**Planning Commission Meeting**  
**Wednesday, July 19, 2017 at 6:00 p.m.**

**TO:** Planning Commission  
**FROM:** Jerry Haddix, Village Administrator  
**RE:** Case 17-07P, Site Plan Review for Primrose School of South Lebanon  
**DATE:** July 17, 2017

Primrose School Site Plan  
Review #1  
Village of South Lebanon, OH

MULTISTEM TREE PLANTING AND STAKING

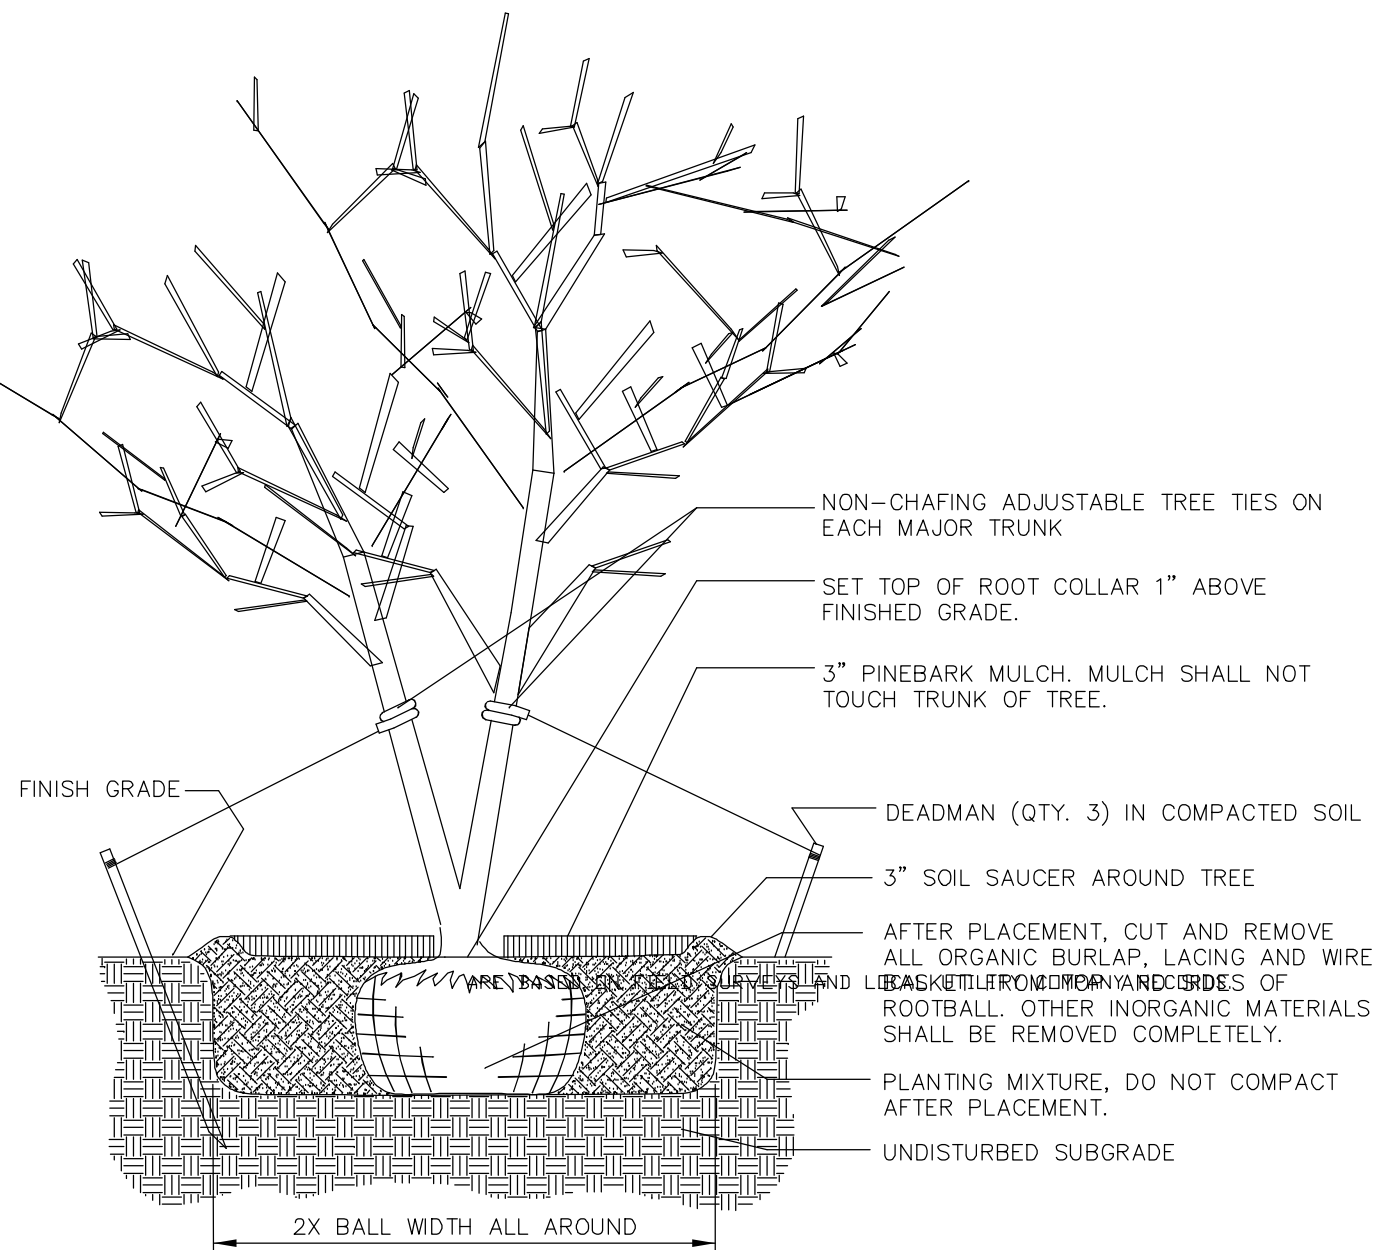
- Text overlap on the "Multi-stem tree planting and staking detail".
